**FINAL DRAINAGE REPORT
FOR
ELLCOTT TOWN CENTER – FILING NO. 1**

April 19, 2006
Revised June 23, 2006
Revised January 15, 2007
Revised August 24, 2018

SF-18-025

SHEET: C1.05

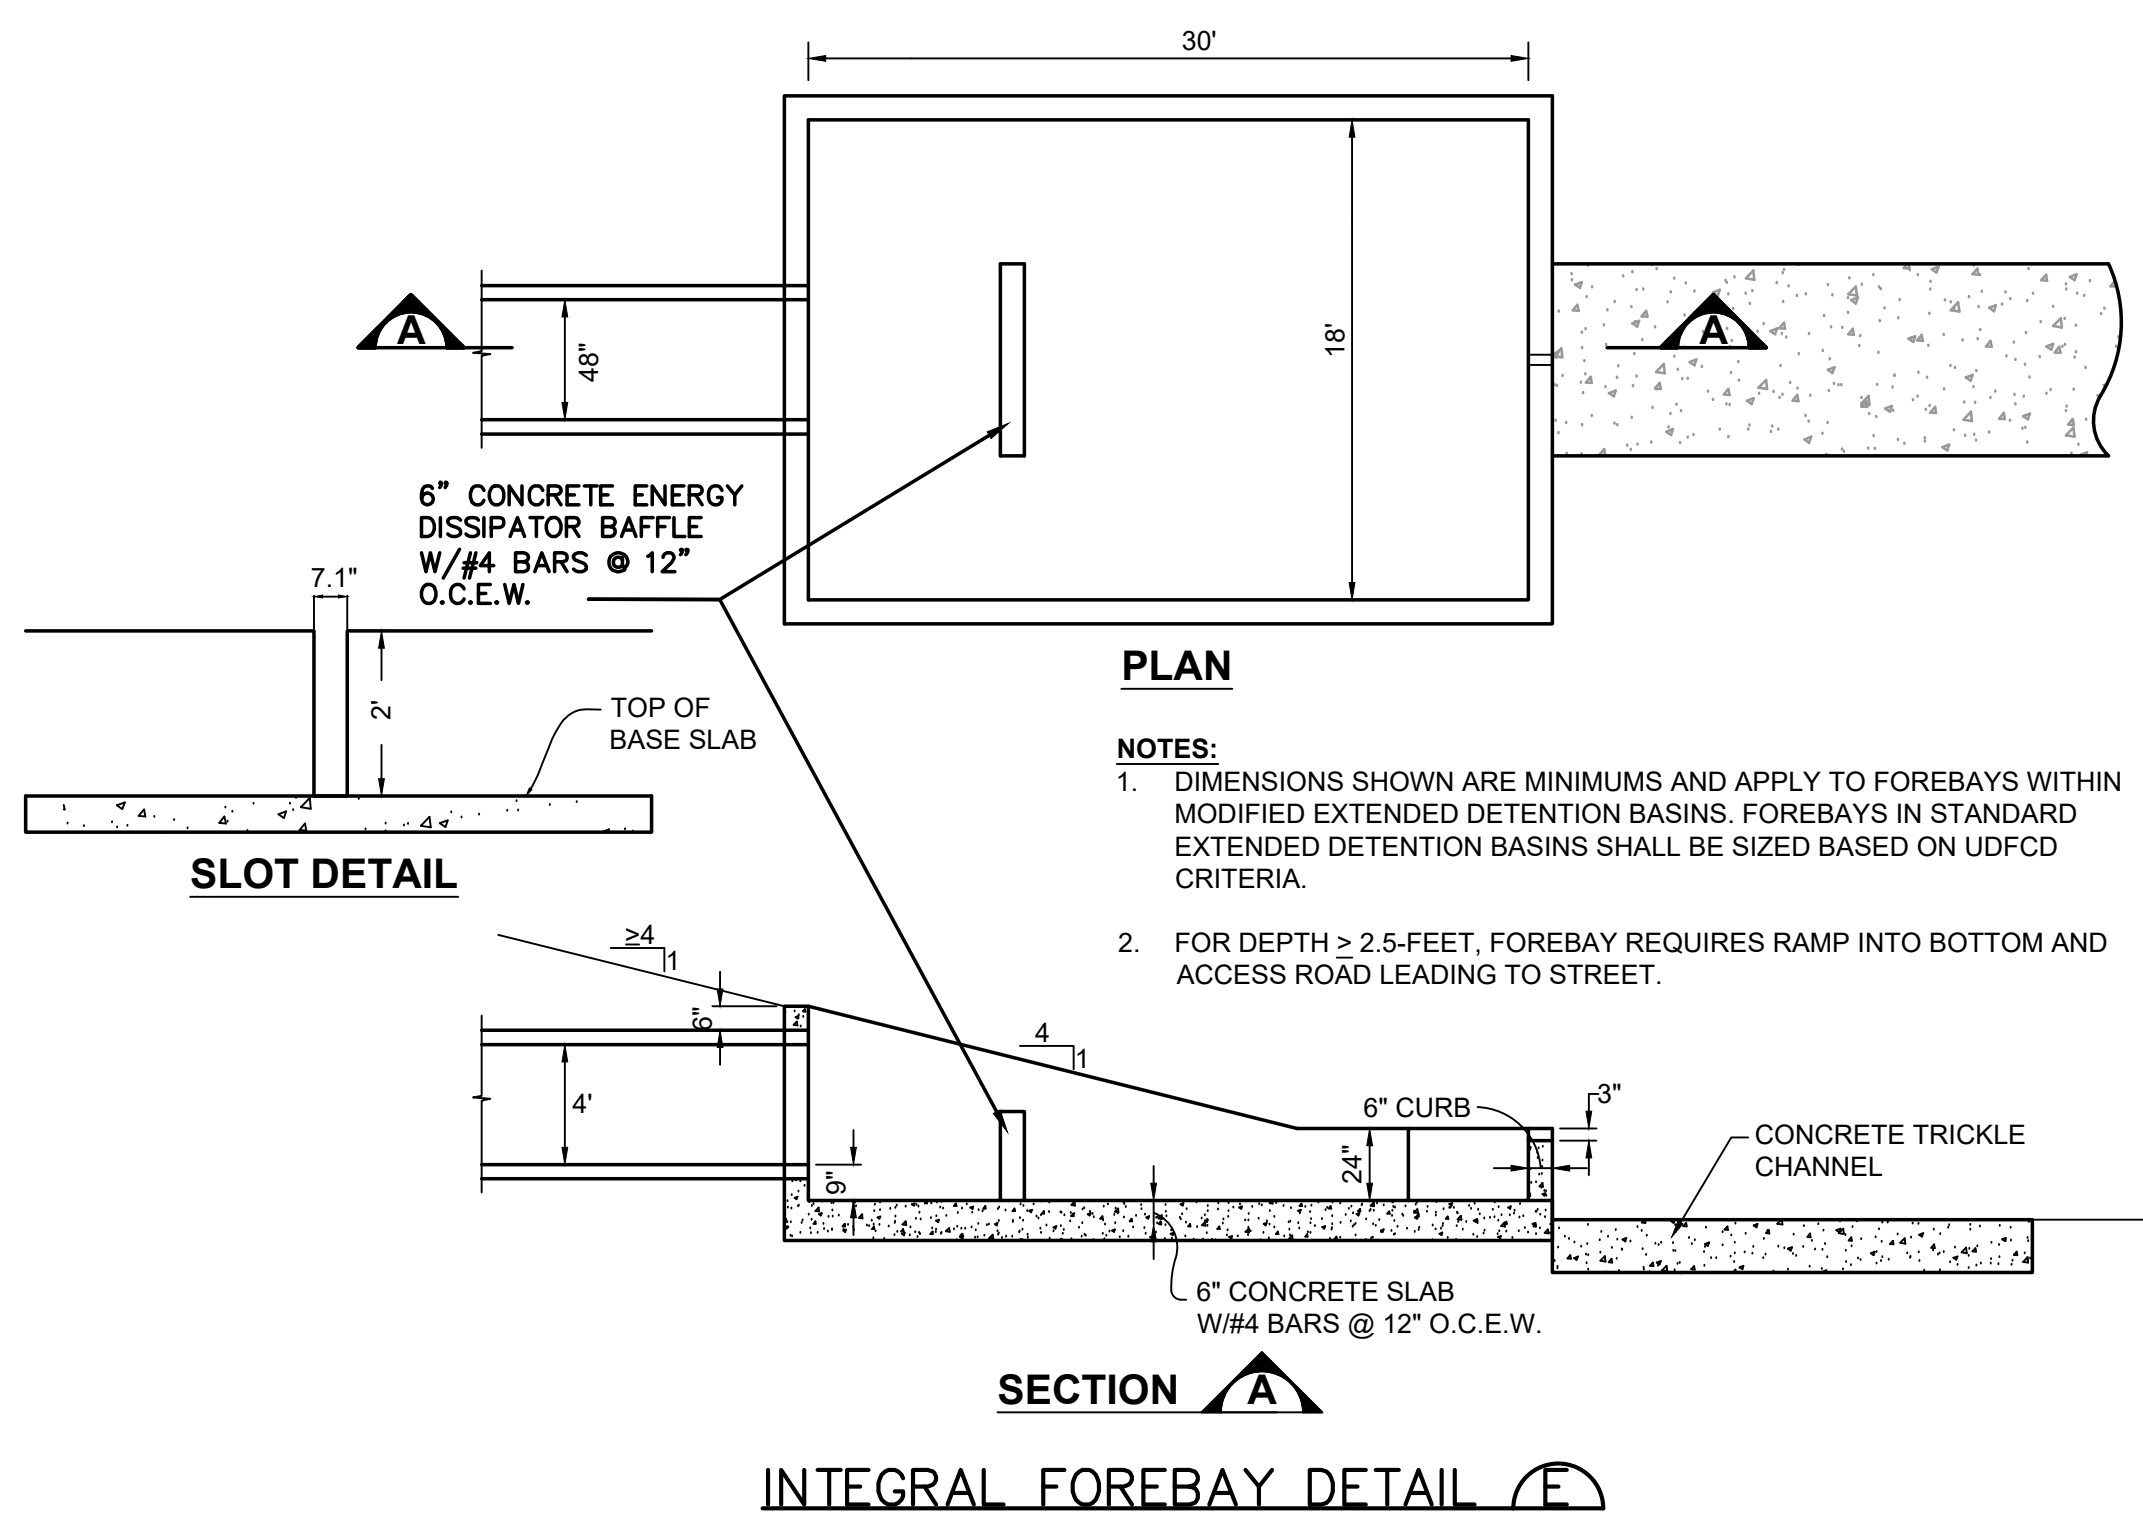
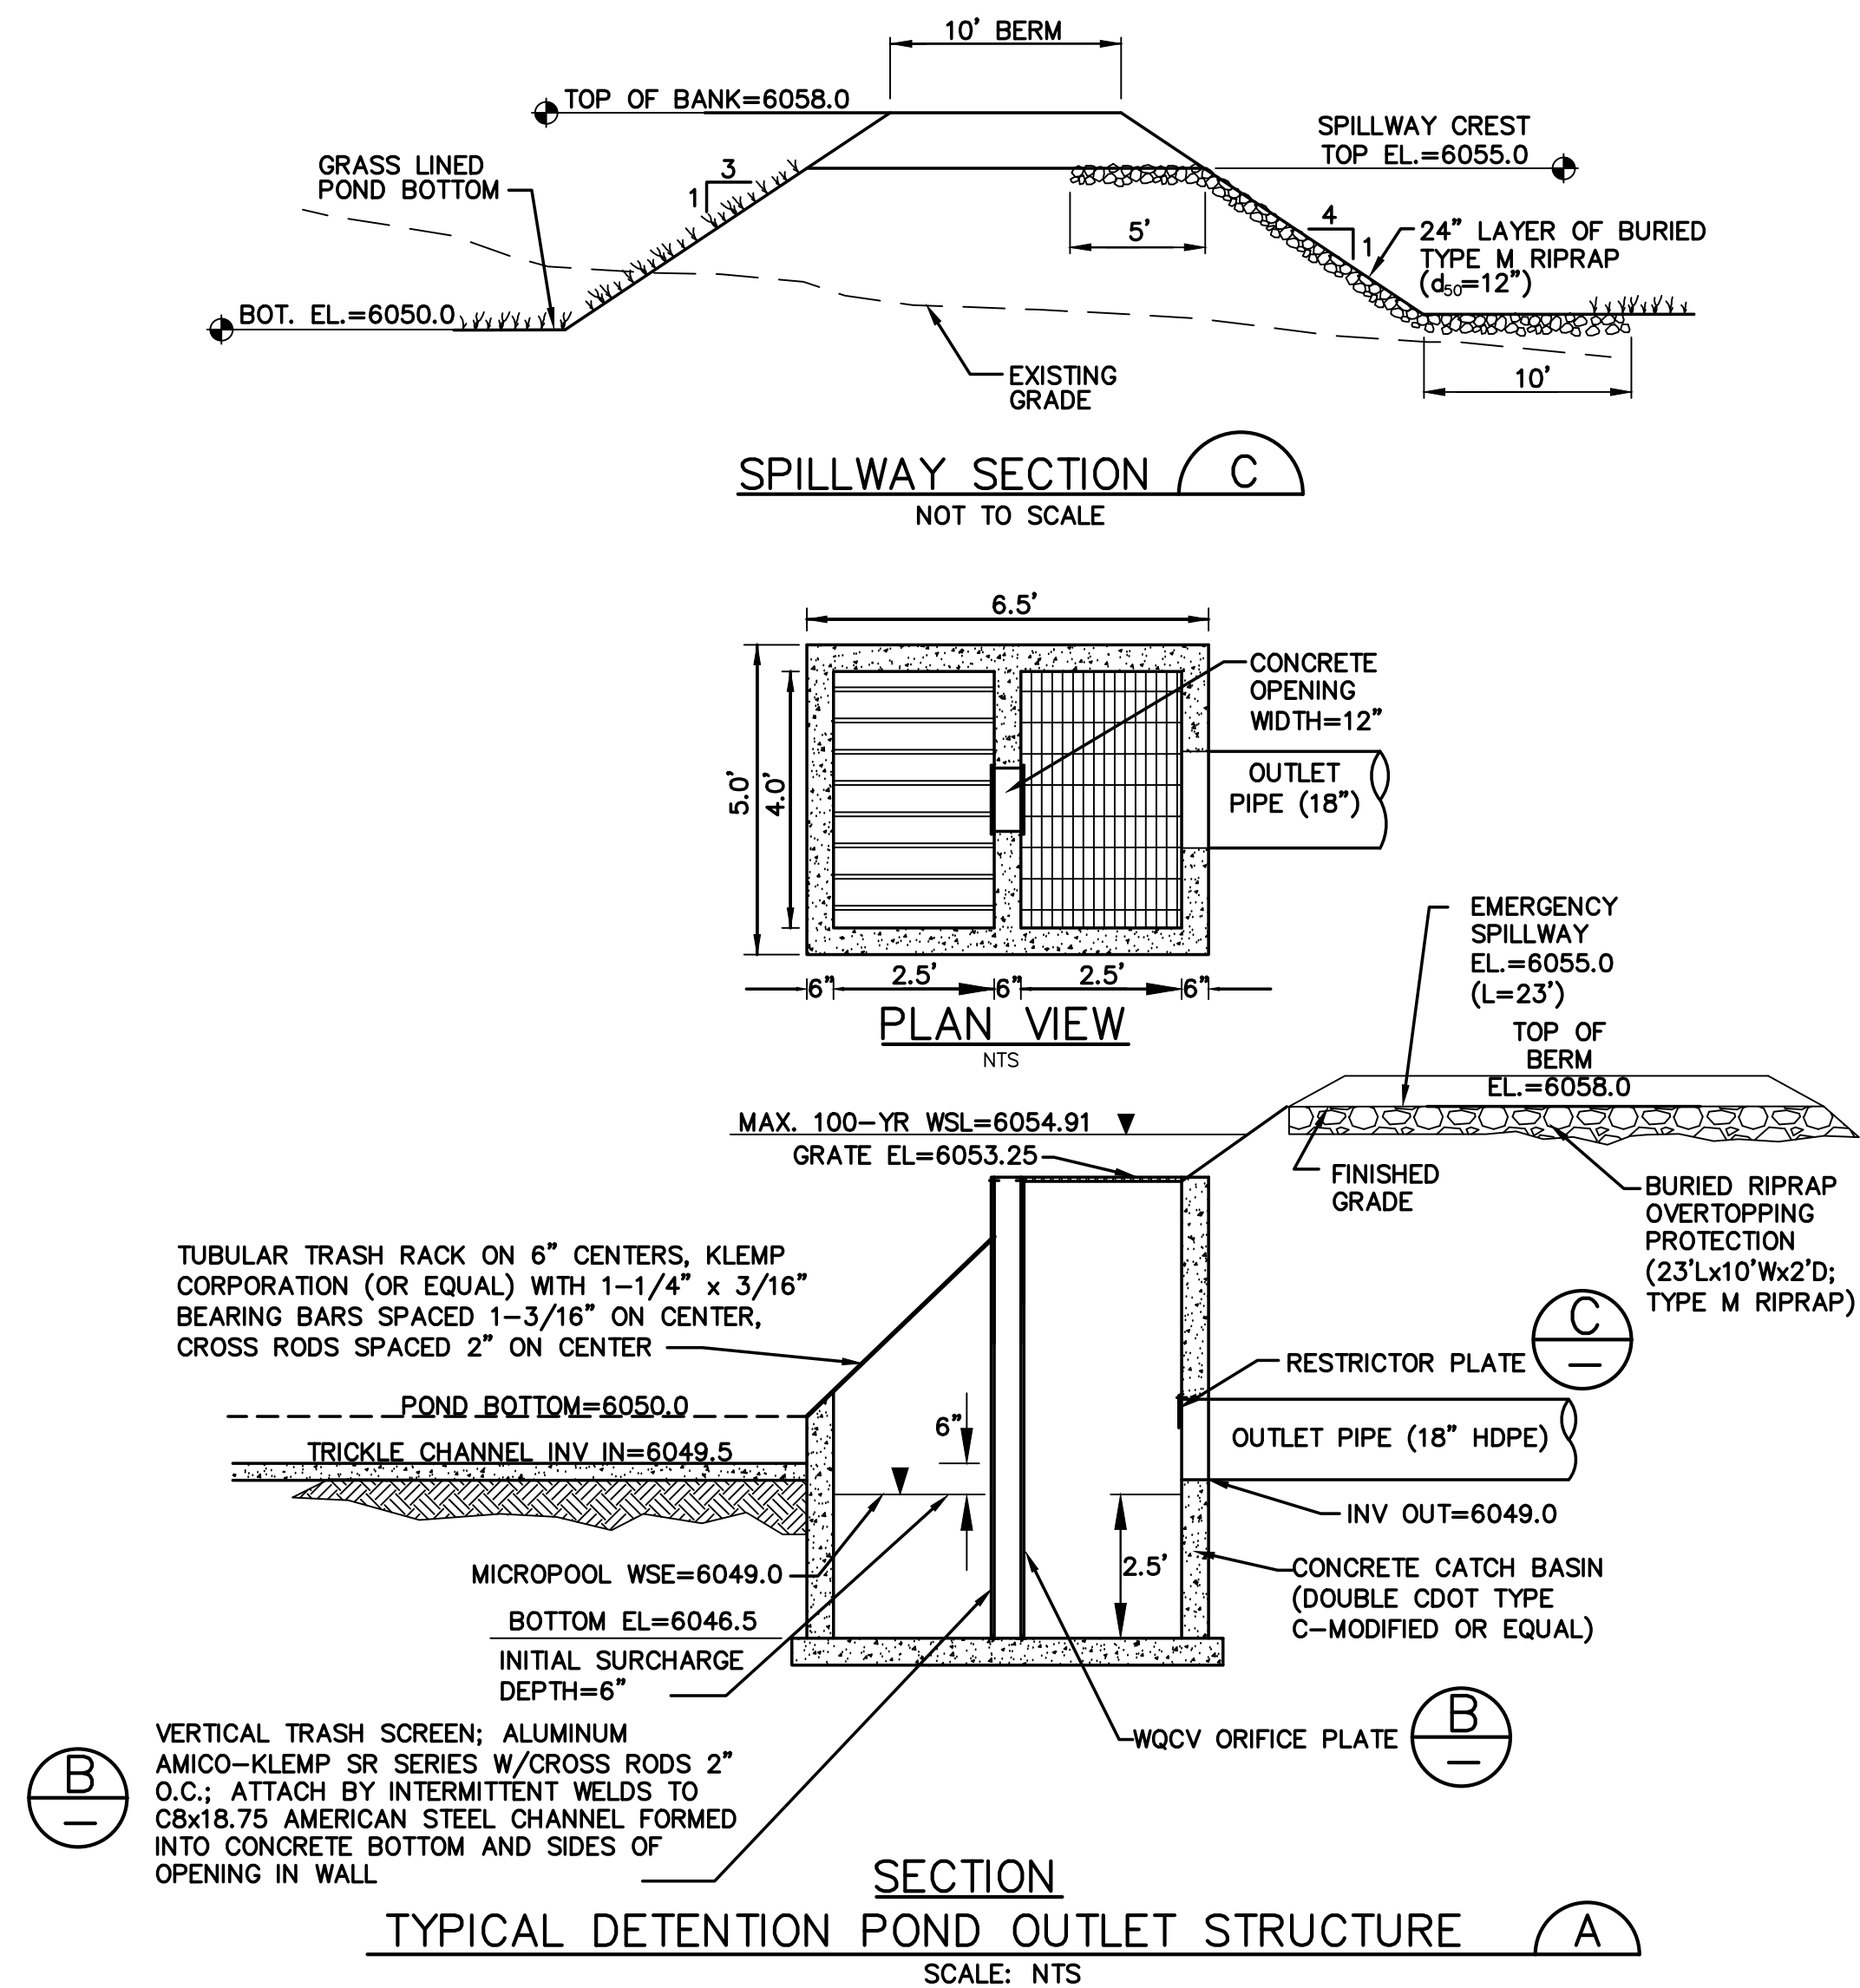
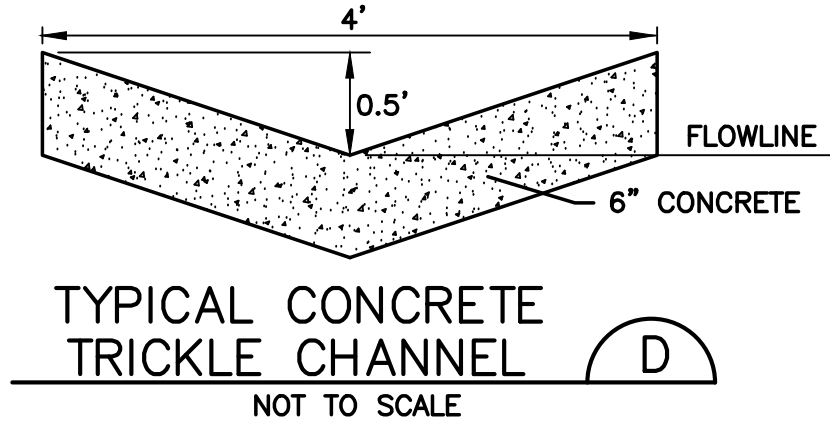
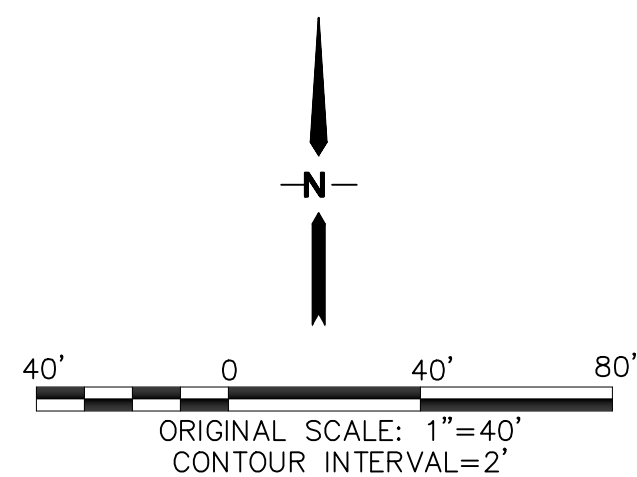
Show maintenance access roads. Access needs to be from the minor road.

Spillway should not be directly over the pipe. Riprap will be sitting on the pipe. Provide profile and detail.
